DELHI DEVELOPMENT AUTHORITY
(MASTER PLAN SECTION)

Draft Minutes of Technical Committee Meeting held on
8.2.91 at 9.30 A.M. in the Conference Room of Vikas
Minar, 5th Floor, Delhi Development Authority, I.P.
Estate, New Delhi.

Proposal for construction of
Sub : Grade separator proposal Ring Road/Najaf-
garh Road Intersection/Raja Garden Crossing.

LOCATION PLAN

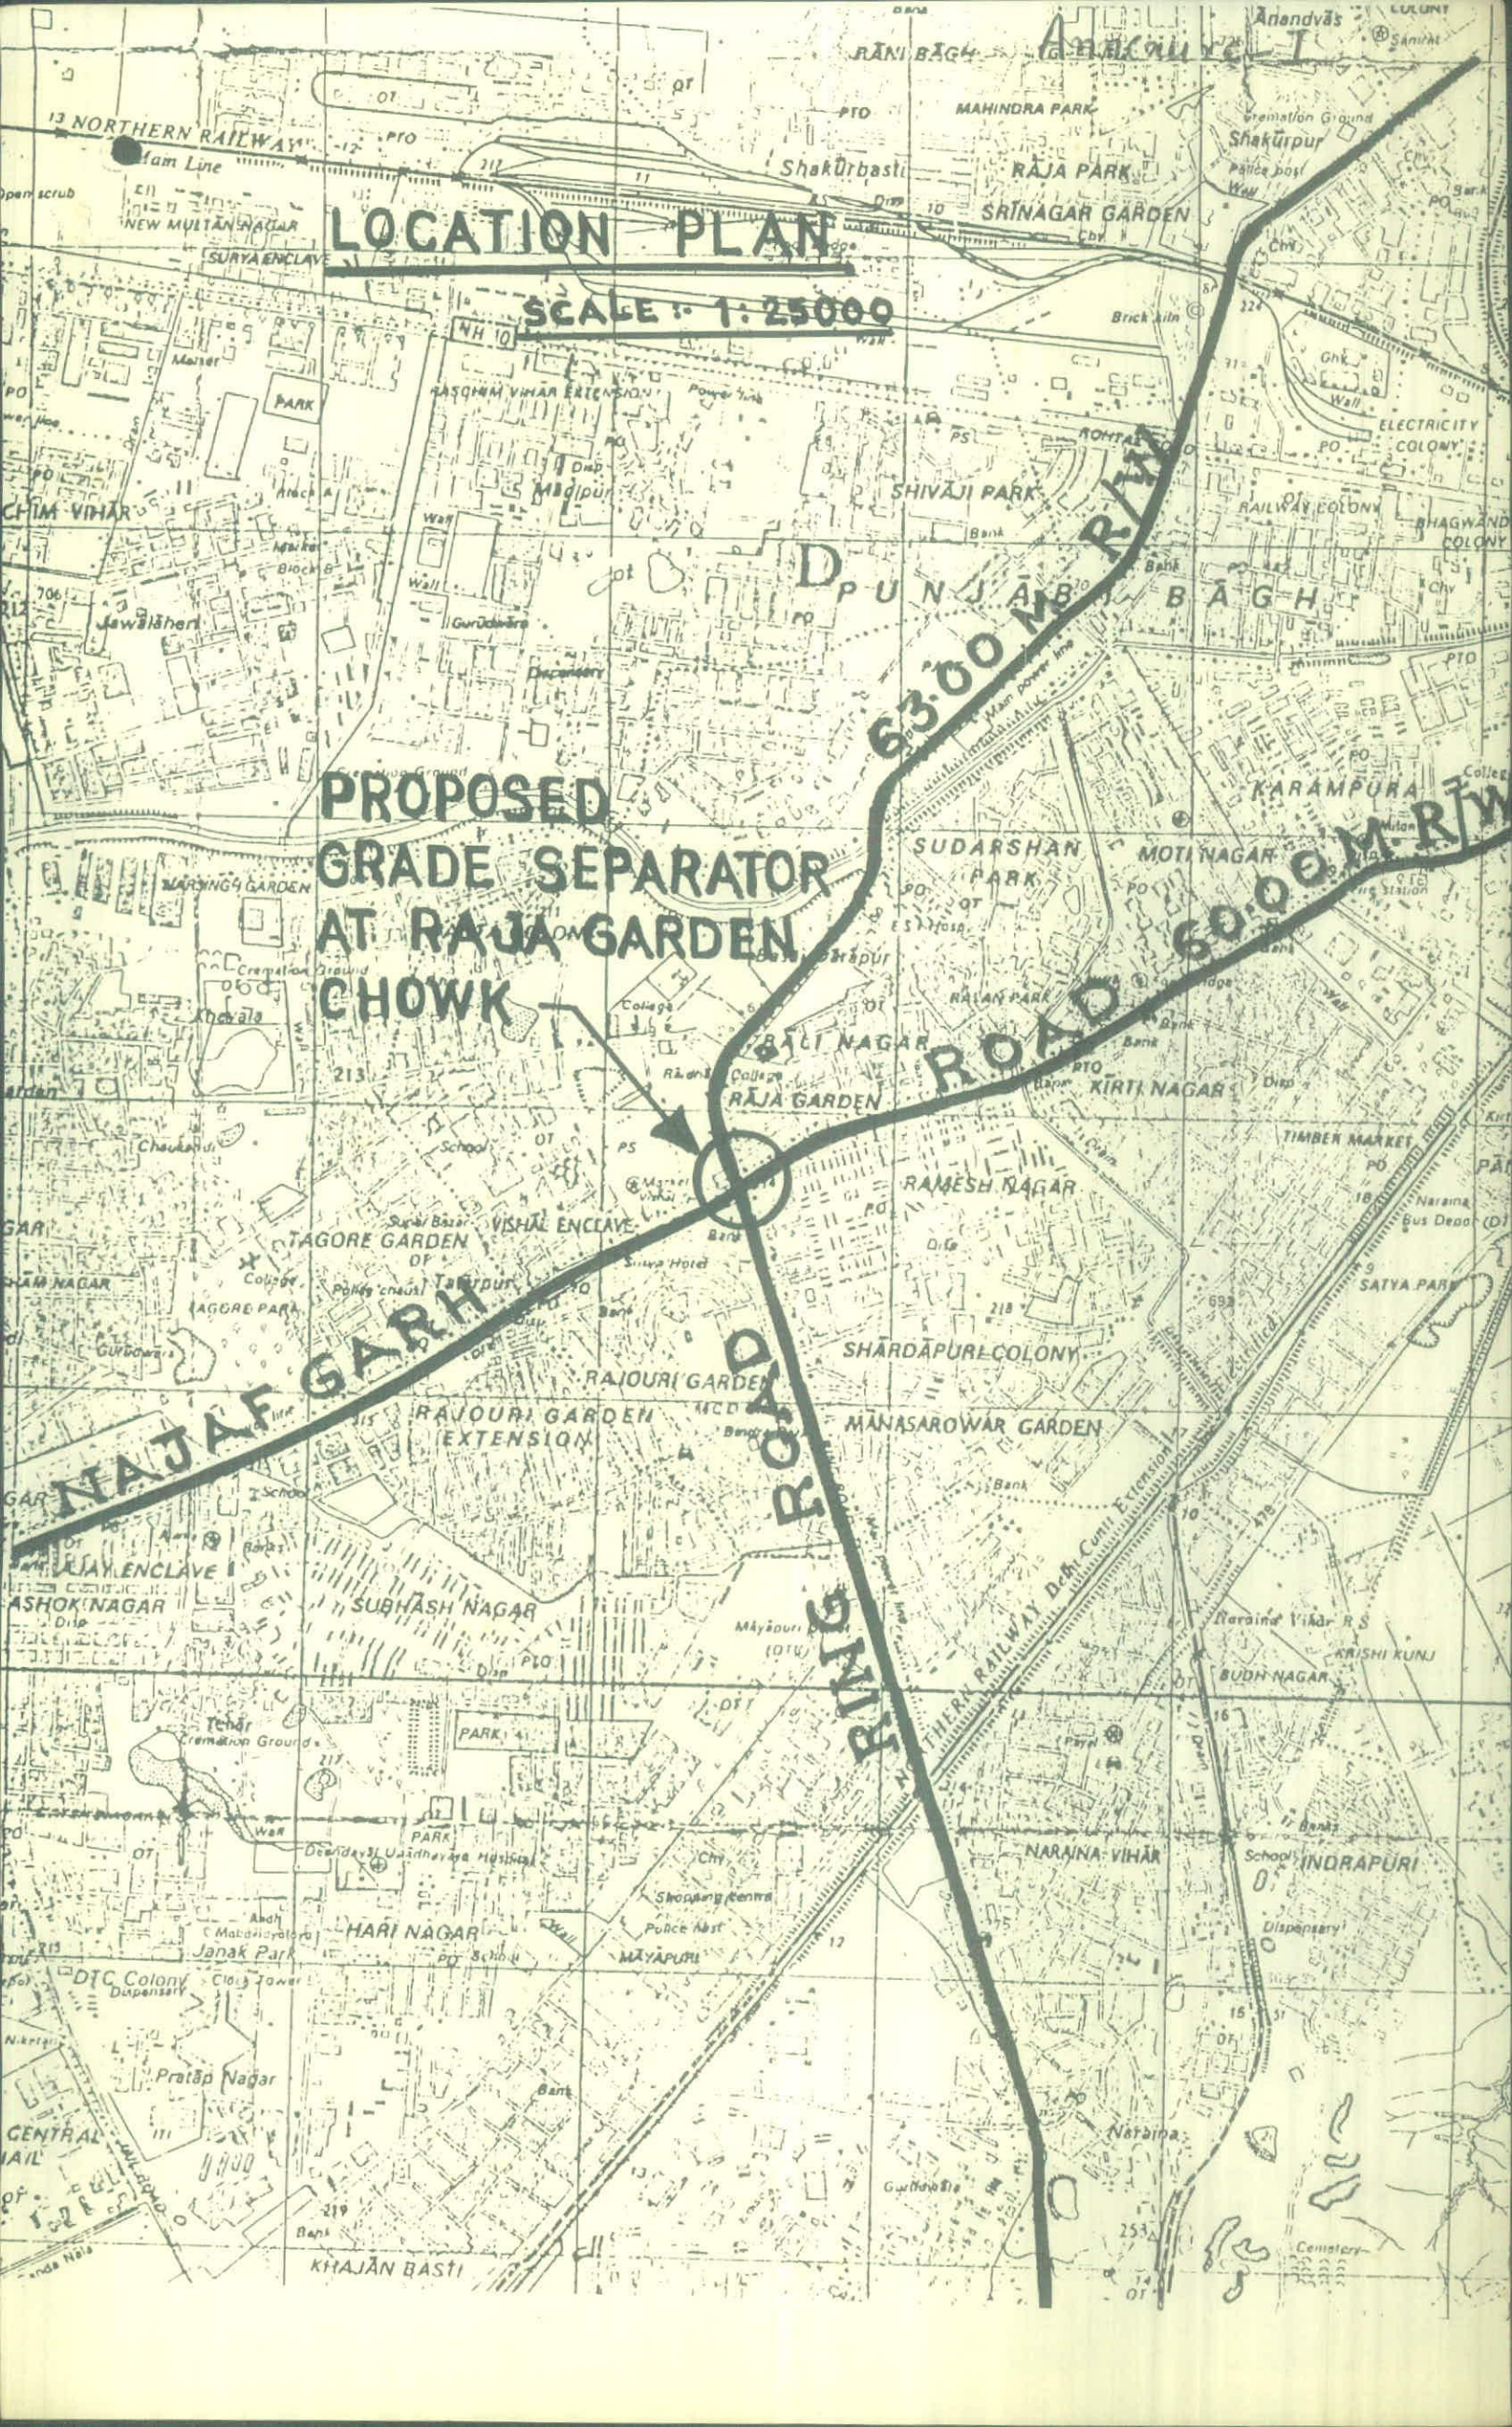
Rajagarden is an important intersection on the western part of Ring Road. The R/W's of Ring Road and Najafgarh Road are 63 mts. & 60 mts. respectively as per MPD-2001. A grade separator at this intersection is identified in MPD-2001. Location plan is placed as Annexure-I.

PROPOSED
GRADE SEPARATOR
AT RAJA GARDEN
CHOWK

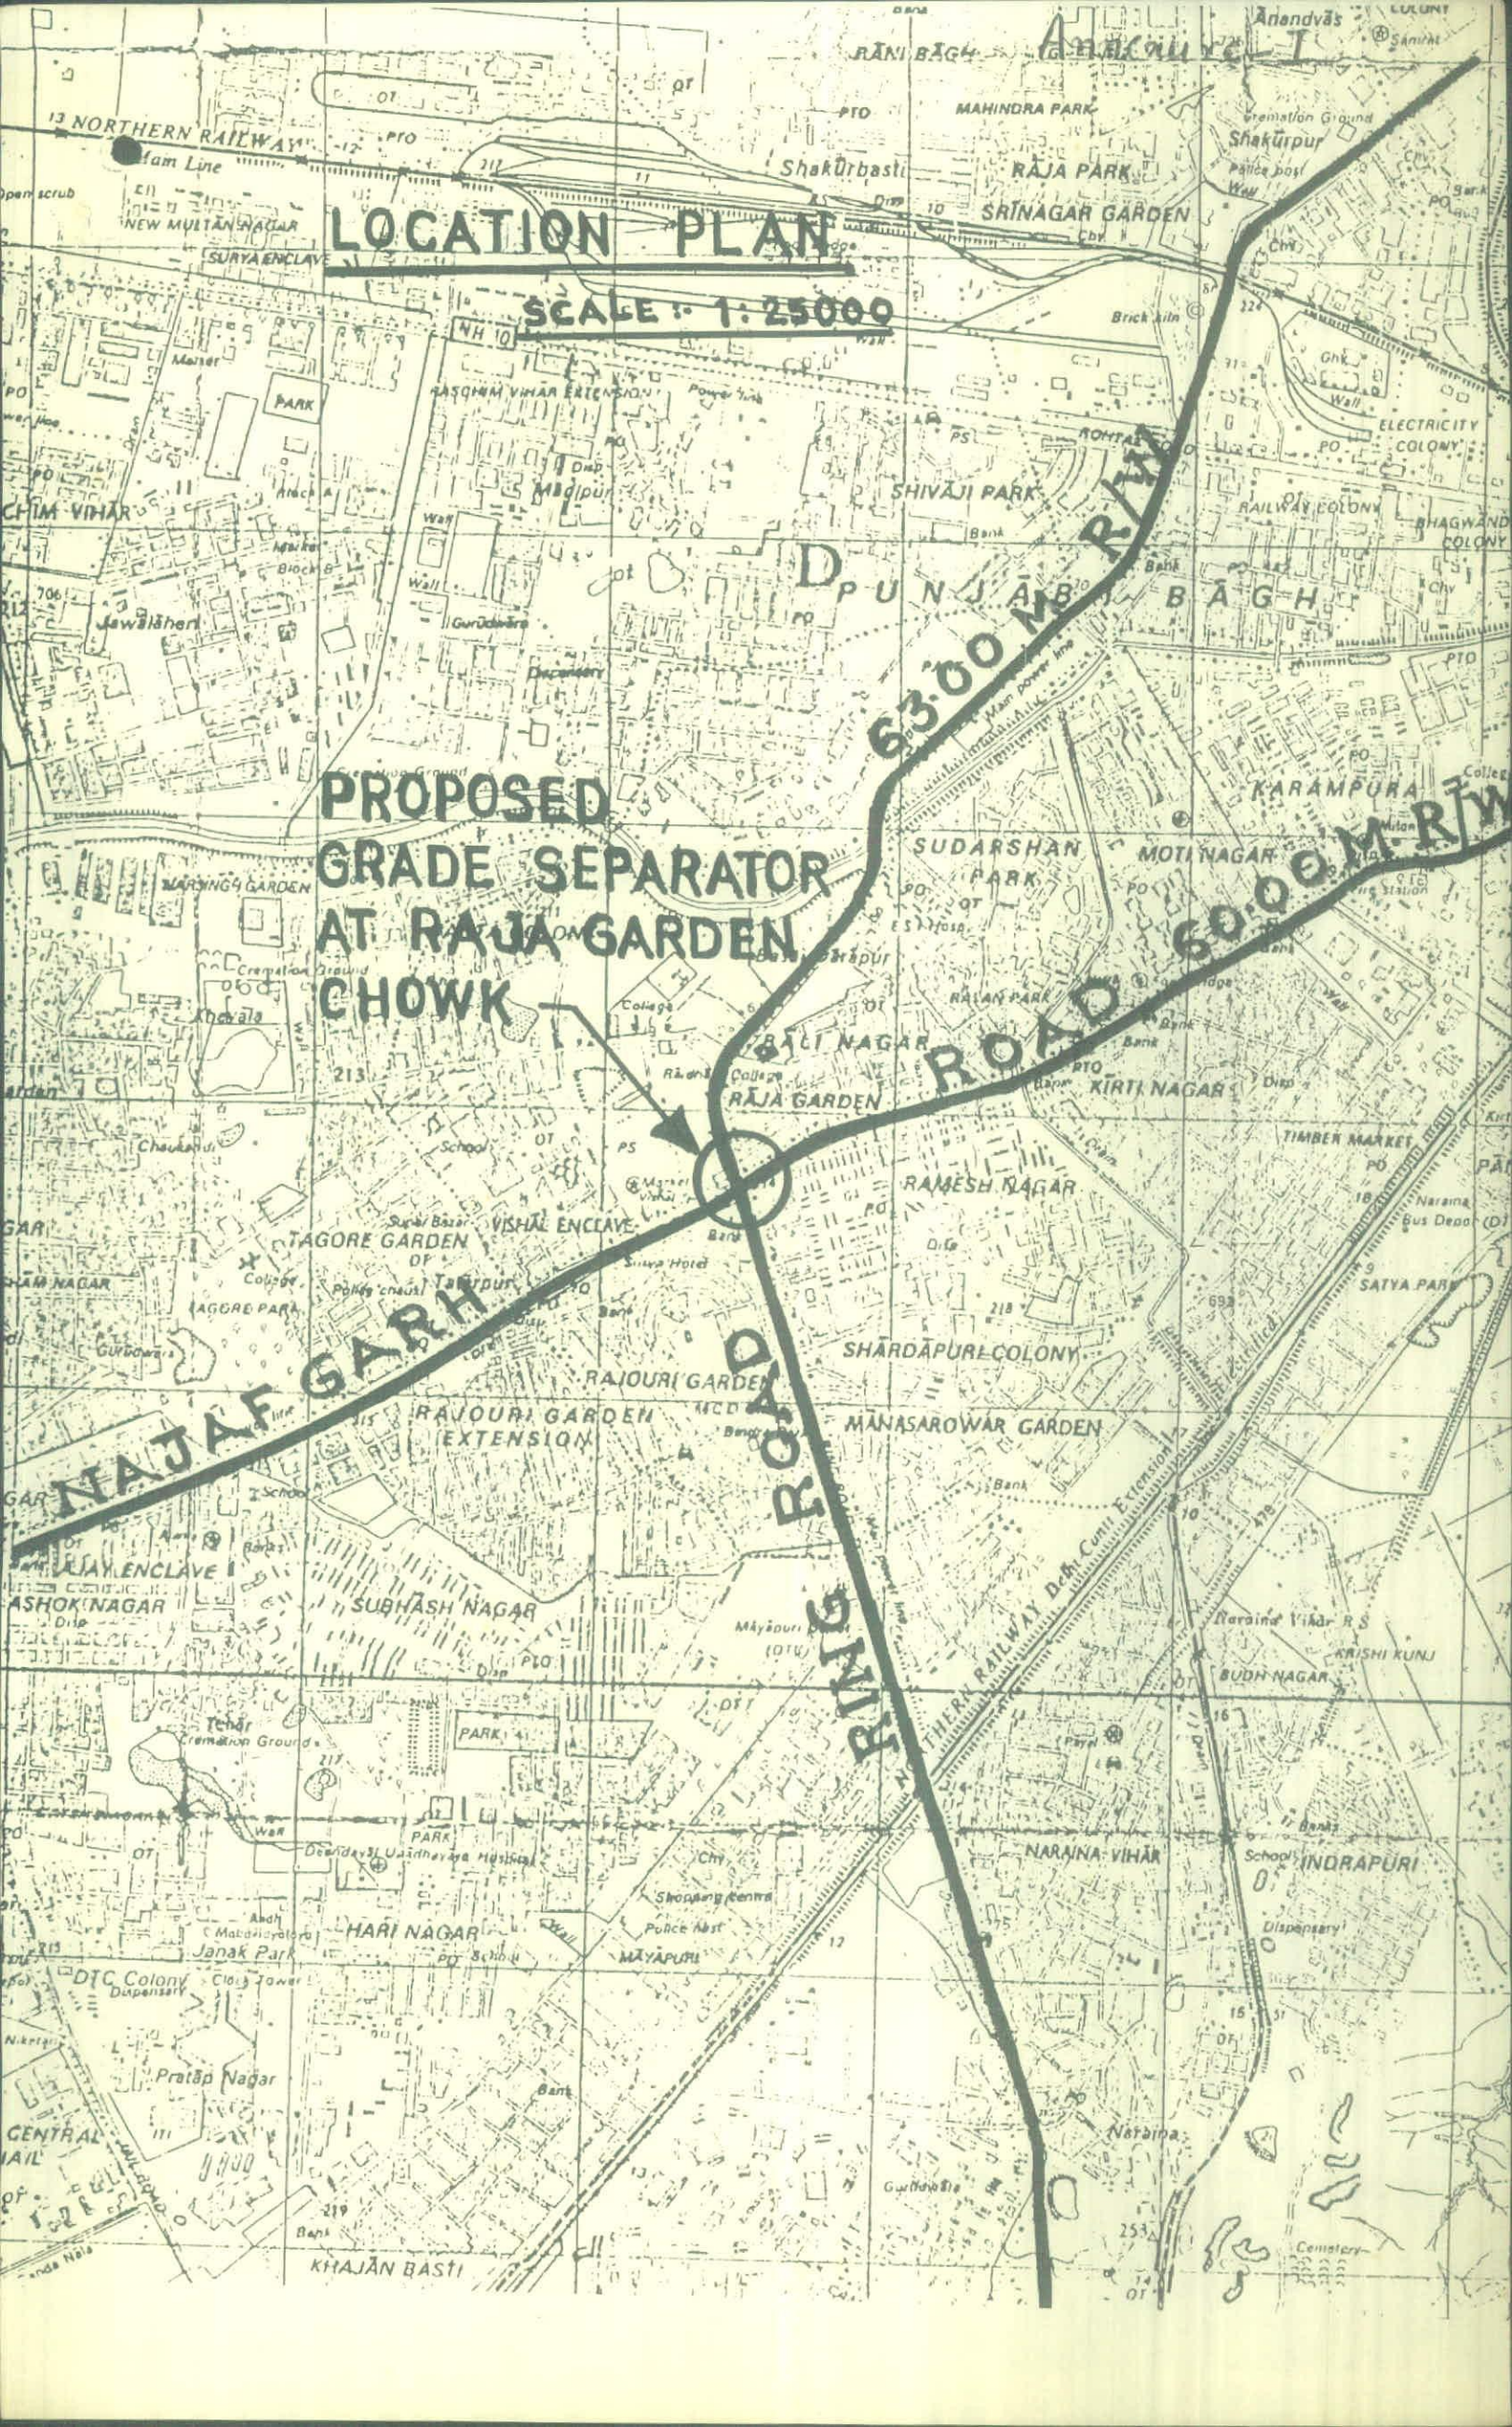
| I. The grade separator design should provide for smooth movement of cyclists depending upon the volume by design or by traffic movement. | Cyclists shall use the intersection at surface level for cross movements. |
| V. A proper landscape plan shall be prepared for the scheme. | This shall be submitted to DUAC after the scheme is approved by Technical Committee. |

The available R/W of Ring Road on the Northern & Southern sides is 59.0 mts. & 35.0 mts. respectively as against the proposed R/W of 63 mts. The available R/W on Najafgarh Road is 45 mts. against the proposed 60 mts. PWD(DA) may ensure the availability of clear R/W's as proposed in the plan for the construction of service roads, inner footpaths & carriage-way at the surface level before the construction of fly-over is taken up.

PRESENT AND PROJECTED FUTURE PEAK HOUR TRAFFIC VOLUMES AT RAJA GARDEN (PCU)

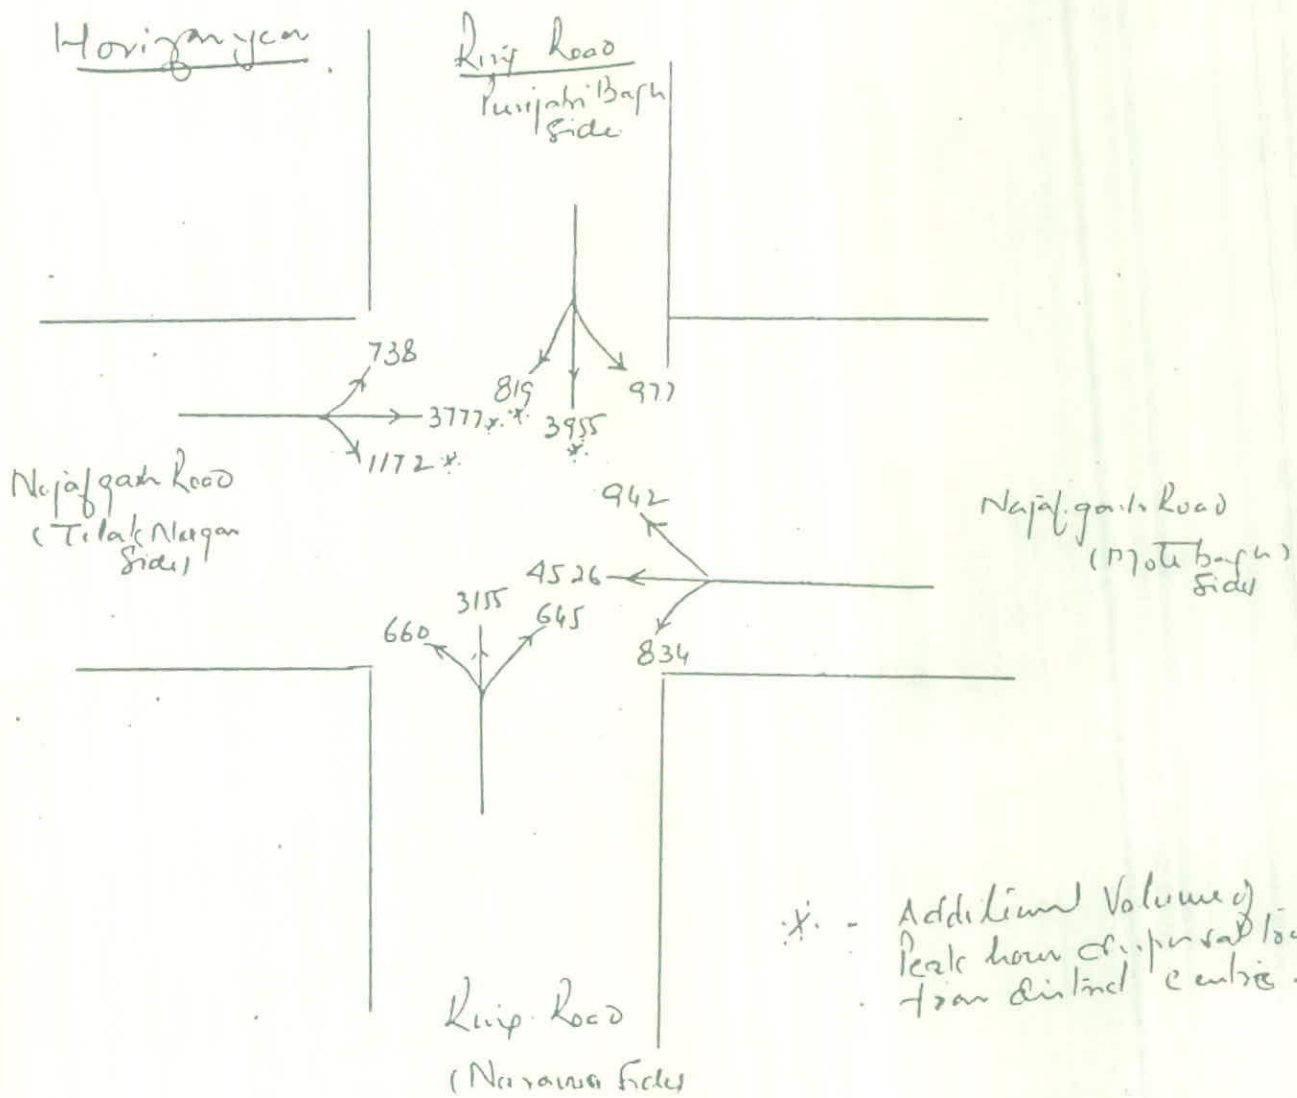
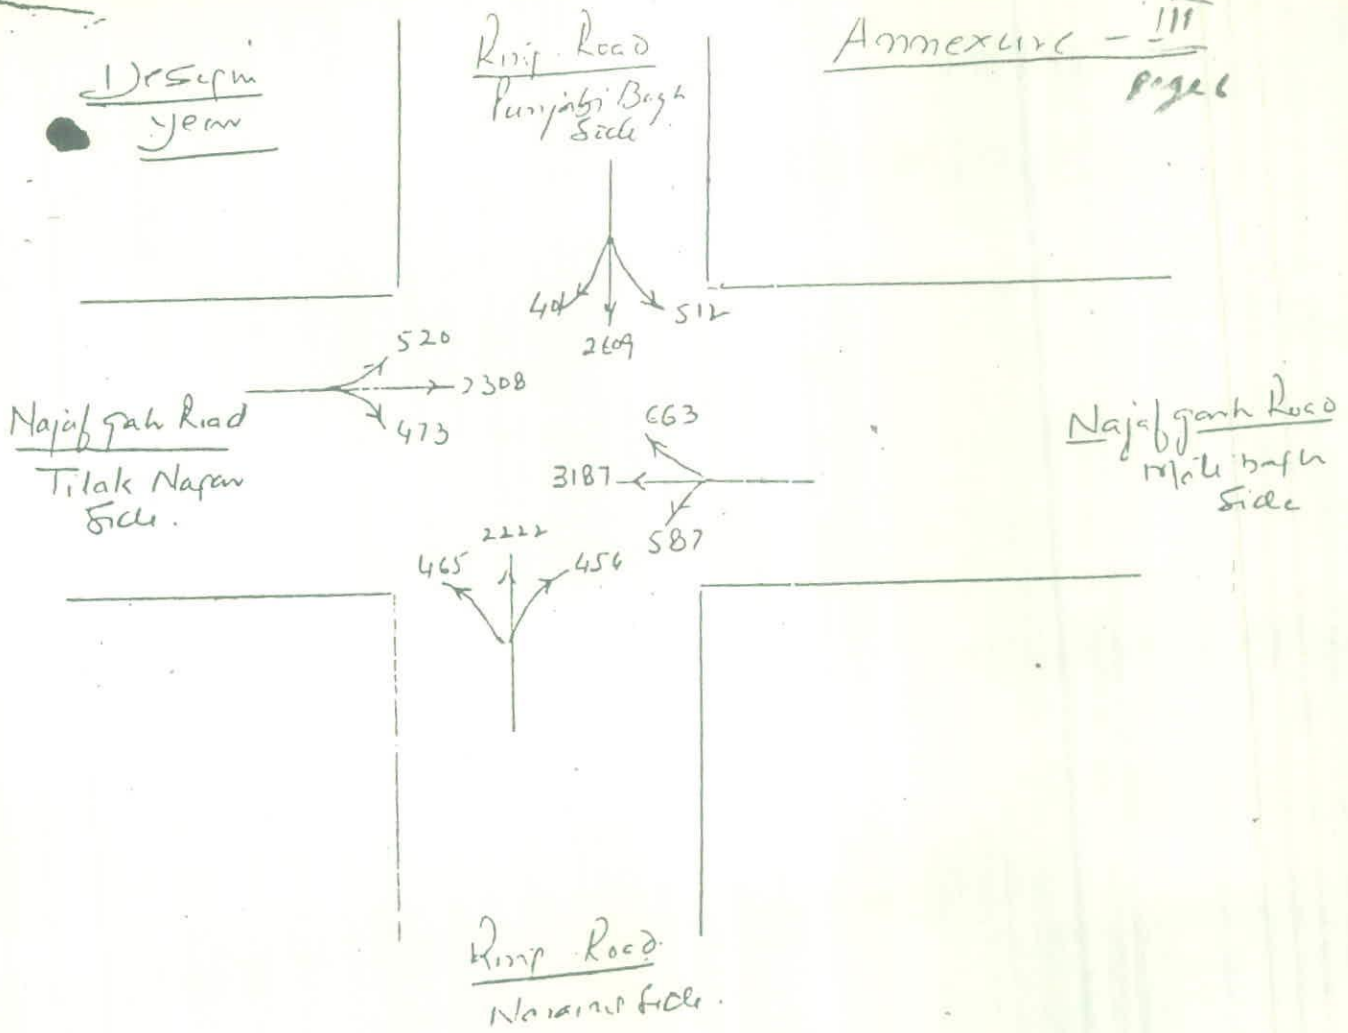
iii) Show the turning movements in each hour in PCU's on each arm of the junction/intersection. (For design year & horizon year).
